U.S. Nuclear Regulatory Commission
Washington, DC 20555-0001
ATTN: Document Control DeskLimerick Generating Station, Units 1 and 2
Renewed Facility Operating License Nos. NPF-39 and NPF-85
NRC Docket Nos. 50-352 and 50-353

Subject: Response to Request for Additional Information
Application to Implement an Alternate Defense-in-Depth Categorization Process, an Alternate Pressure Boundary Categorization Process, and an Alternate Seismic Categorization Process in Accordance with the Requirements of 10 CFR 50.69, "Risk-Informed Categorization and Treatment of Structures, Systems and Components for Nuclear Power Reactors"

Response to Request for Additional Information
License Amendment Request
10 CFR 50.69 Alternate Categorization Processes
Docket Nos. 50-352 and 50-353
June 30, 2022
Page 3

Attachment 1: Response to Request for Additional Information - License Amendment Request, Application to Implement Alternate Categorization Processes in Accordance with the Requirements of 10 CFR 50.69.
Appendix A: Revised Proposed FOL Appendix C License Condition Markups

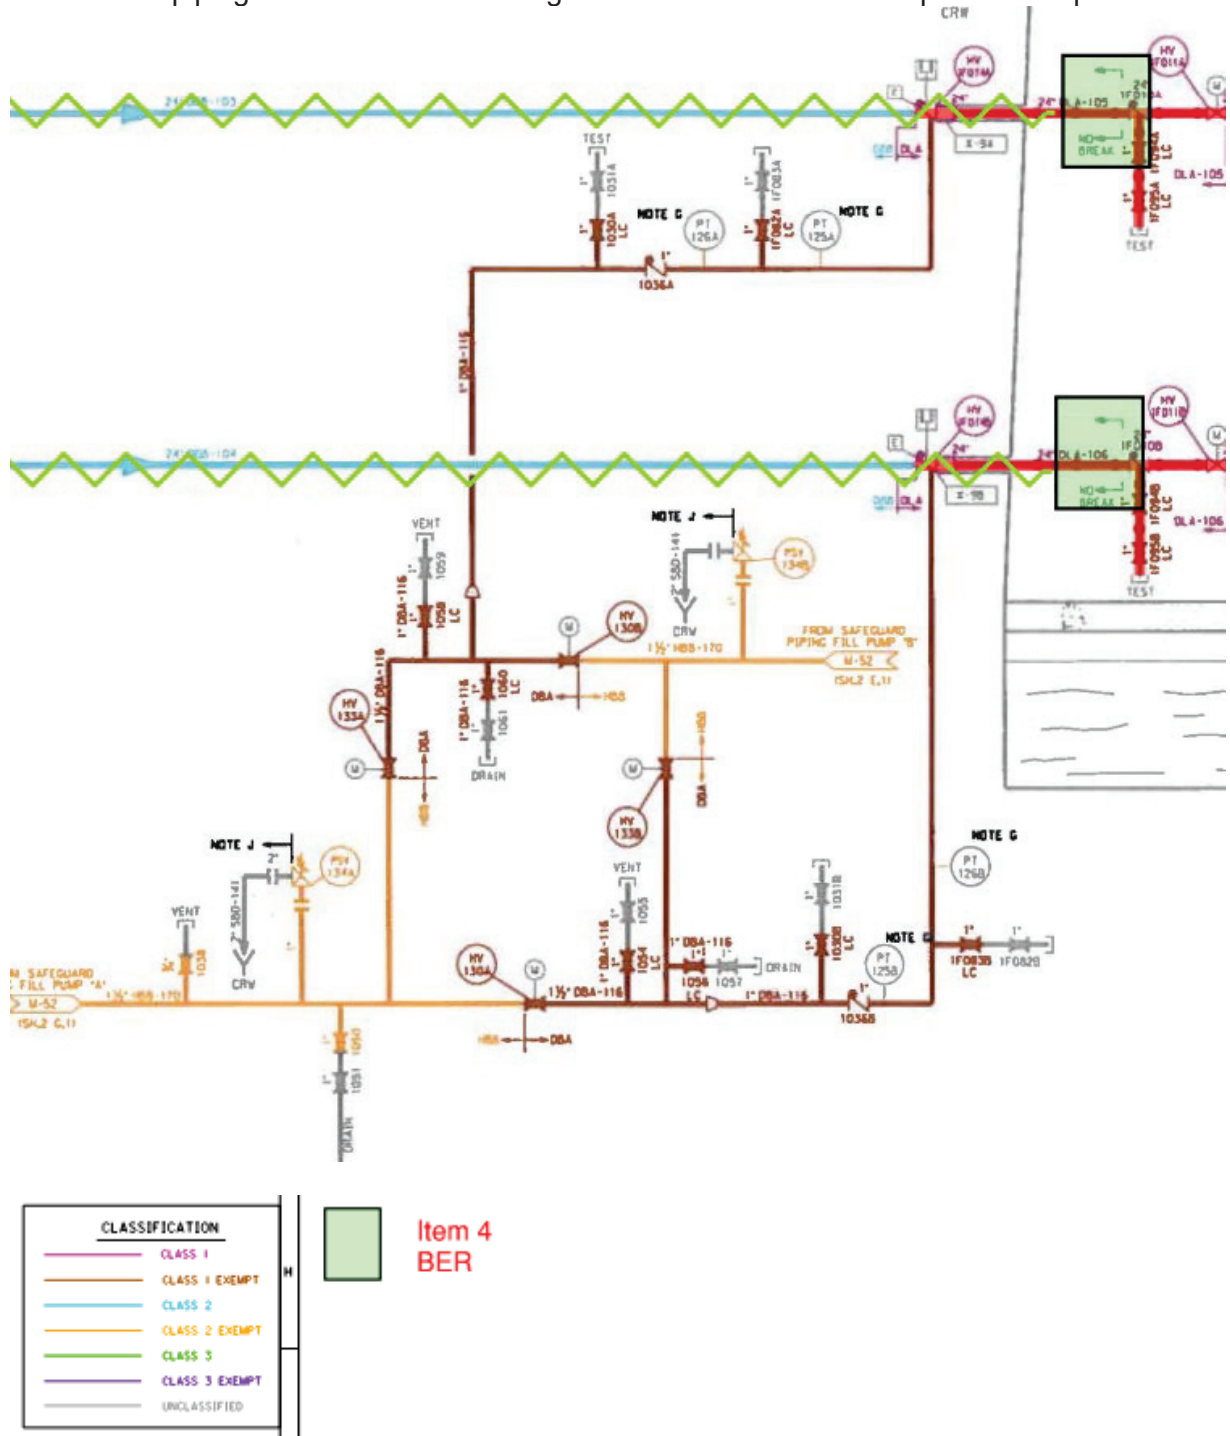
- B. Discussion and justification that support the licensee's conclusion that the pilot categorization results are reasonable and consistent.*

The HSS portions of piping found in the current methodology were predominately the same as those found in the proposed EPRI methodology. There are two exceptions to this. What was different was the addition of BER piping not found in the current methodology. Constellation considers this is a conservative, acceptable addition to the scope of HSS piping. The reduction in HSS piping segments occurs with small instrument, drain, or supply piping like the example depicted below for Reactor Feedwater. In the figure below, the Safeguards Piping Fill system is connected to the 24" reactor feedwater system with 1" piping highlighted in brown. Failure of this piping would

not prevent the plant from shutting down with normal makeup. Thus, it is reasonable that this class of piping be excluded from being HSS due to the nominal impact on the plant.
